C-NAVY-03-09-3087W

Project Number 112G00632

March 11, 2009

Subject: Response to Comments,  
100% Design Report, Replacement Stone Revetment, Site 09  
Naval Station Newport, Newport RI

Figure 2-4. Revetment toe protection (Designs I through VI)

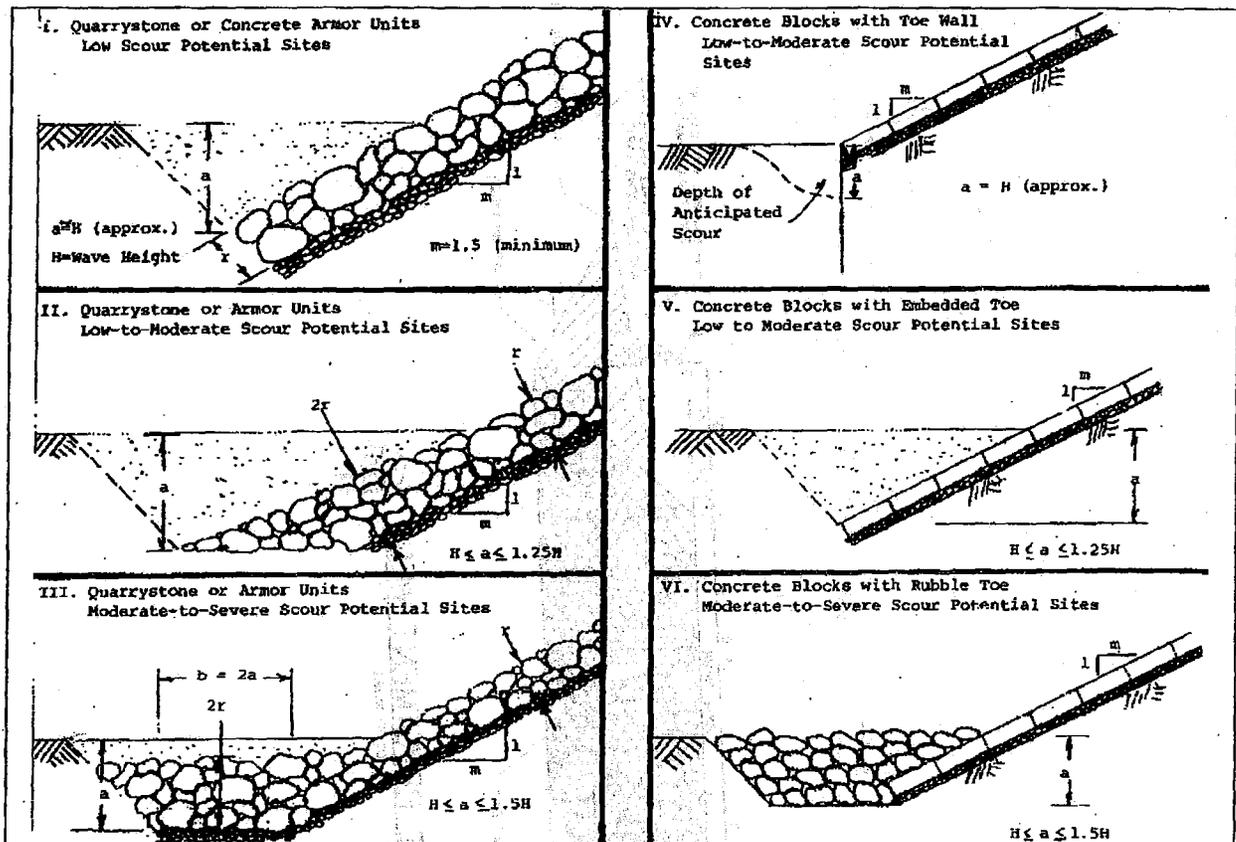
1. **Comment:** *In general, the revetment "toe" design is considered excessive and is not considered "as close as practicable" to the shoreline feature. The "Stone Revetment West" (Typical Section/Detail "2", sheet C-8) is not consistent with cover stone layer thickness calculated in "Shoreline Stabilization Calculation" (sheet 4 of 17, dated 4/29/08), but rather "includes only the toe portion of the revetment" (page 4-3 narrative, "Shoreline Stabilization Toe Configuration), which is sized from "Figure VI-5-50 Typical Seawall Toe designs where scour is foreseen" (Calculations, sheet 17 of 17).*

*The intent of the toe protection is to prevent scour from wave induced turbulence (at the base of a slope) eroding the bottom sediments which support the armor layer permitting displacement or slope failure. The selection of the largest toe design geometry, and substitution of this geometry for a conventional revetment slope results in excessive disturbance and elimination of coastal beach area.*

The 30% design for this revetment was completed by incorporating the guidance contained in the *Design of Coastal Revetments, Seawalls and Bulkheads*, EM 1110-2-1614 (USCOE, 1995). The guidance for the toe configuration was based on Figure 2-4 of that guidance, configuration III (attached). It should be noted that this configuration is nearly identical to the toe configuration suggested in Comment No. 2 for the eastern portion of OFFTA. Figure 2-4 does not specify what elevation the toe is to be buried beneath so the source document for these figures was consulted (EM 1110-2-1601). That document indicates that for trench filled revetments riprap should be placed to the low water level (Page 3-10). This was interpreted to mean that the ground surface on Figure 2-4 was the mean low water line, therefore the toe was buried below the mean low water line in the 30% design.

Concerns were raised about the stability of the excavation while digging to this depth in the intertidal zone. In addition, there were comments raising concerns for excavating this much material in the intertidal zone. In order to alleviate these concerns, the toe configuration was changed in the 90% submission. The toe configuration was changed to a type that would not need to be buried to such a depth because it contains additional rock that will fall into the scour hole and protect the revetment if scour occurs. The tradeoff was that a larger toe configuration was used, however it required less excavation. It should be noted that in order to satisfy the RIDEM comments on the design, where an existing coastal beach exists the toe was still buried deep enough to be covered with two feet of beach material. On the western portion of OFFTA this requirement was not attempted to be met because this area is not a coastal beach, rather it is a rocky shoreline.

C-7

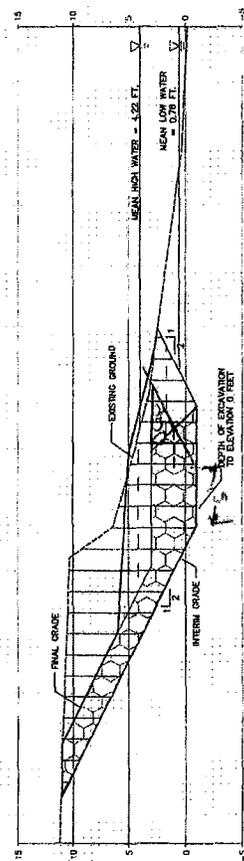
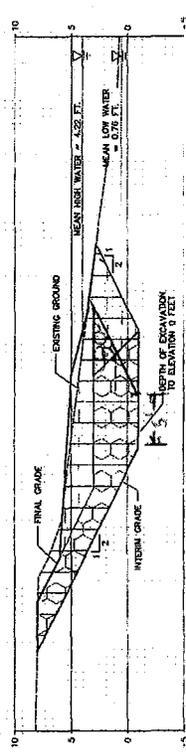
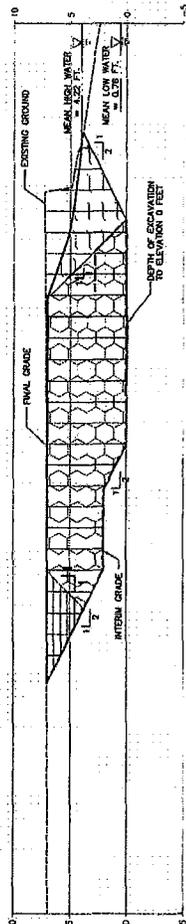
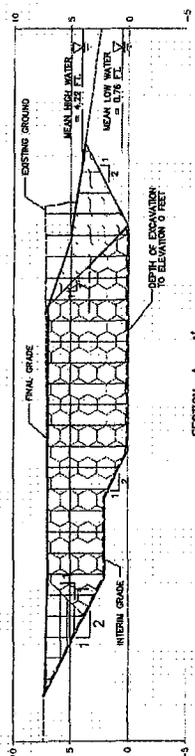
*Figures 4-2, 4-3, 4-4, 4-5 in the main body of the 100 % Design show the reuse rip rap extending from the western end of the site to almost the central portion. Sheet C-7 seems to limit the rip rap to cross section A-A and B-B?, which is only a portion of the western end of the site. If this is the case the sheets do not correspond to the Figures in the main text.*

**Navy Response 3/4/09:** Sheet 7 shows cross sections at specific lines as shown on Sheet C-6. Figure 4-5 shows the extent to where the reused rocky shore material is planned for use. Both are correct, and there is no discrepancy.

Using the toe configuration suggested for the eastern half of the site was investigated. The attached Sheet C-7 showing cross sections has been marked up in red to show how this configuration would look if the toe of the excavation is not lowered further. It should be noted that if this configuration was adopted, approximately 6 feet less of the beach (in width) would need to be excavated; however, the two foot of cover over the toe would no longer be achieved. If the toe were put in deeper to achieve the 2 foot of cover, additional excavation would be required. It is felt that the configuration for the toe presented in the 100% design for the eastern portion of the site should not be changed because the suggested toe would either not achieve the requested 2 foot of cover or would have to be lowered which would actually result in additional excavation of the beach.
